# Access Compliance Report

## Public Rights-of-Way (Curb Ramps)

Intersection ID: 54301	Main Street: GOLF_LINKS_DR	Cross Street: PROVIDENCE_FARM_LN	Location: SW
ADA ID: F66D8BA7346A	Ramp Type: Directional1	Initial Pass/Fail: Fail	Overall Compliance: No
Severity Score: 12.5			
Codes/Mitigation Info/Possible Solution		Field Measurements/Component Compliance

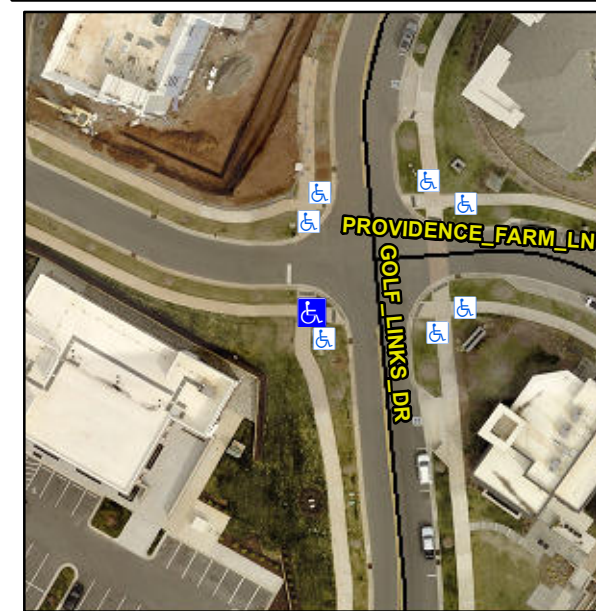
**R304.5.3**

**Remove & Replace Entire Ramp.**
